# Open Rack RSA Initiatives – Fall 2015

Ethan Long

October 9<sup>th</sup>, 2015

Figure 1: Top View of the Open Rack

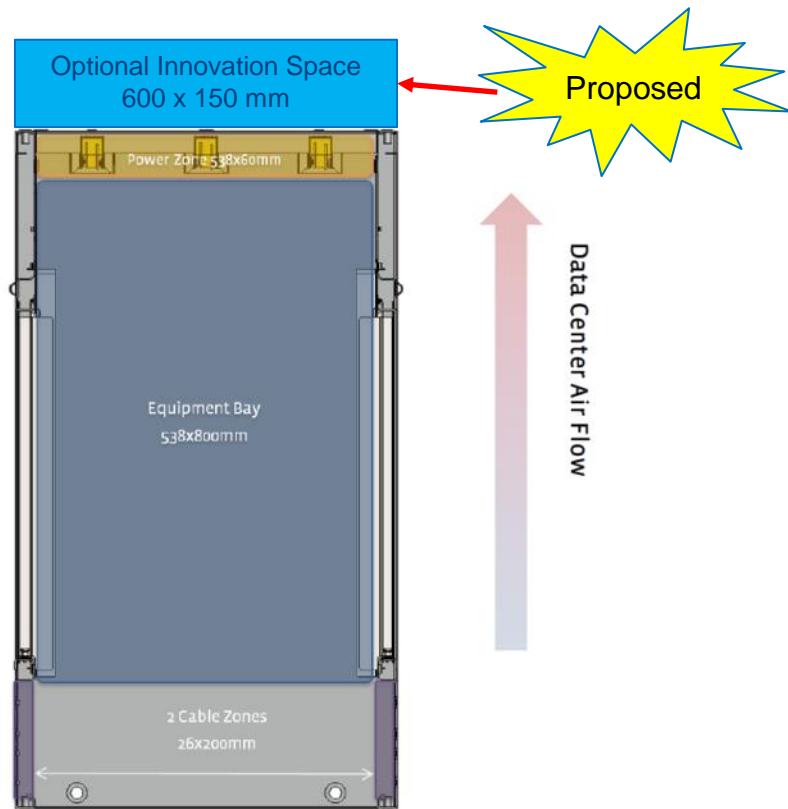
Proposal: Add an optional rear innovation space to Figure 1 of the Open Rack Standard.

- Supports the mounting of rack-level fans or other systems at the back-of-rack
- Allows for innovation while maintaining Open Rack compliance

Rack Back View

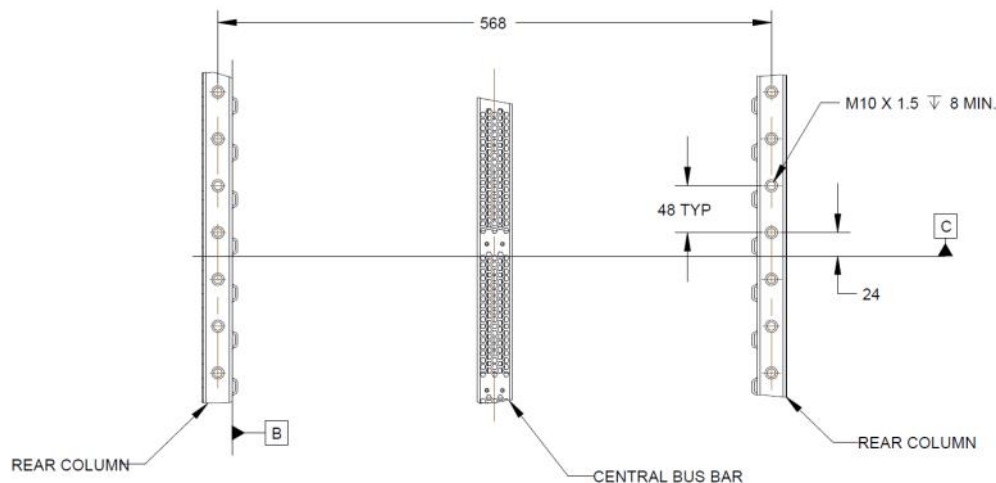
Proposal: Update standard to include mounting features on the Open Rack rear columns

- Provides attachment points for rack fans or other equipment.
- Pattern repeats regardless of rack height.
- Seeking partnership with interested parties to further align on the design
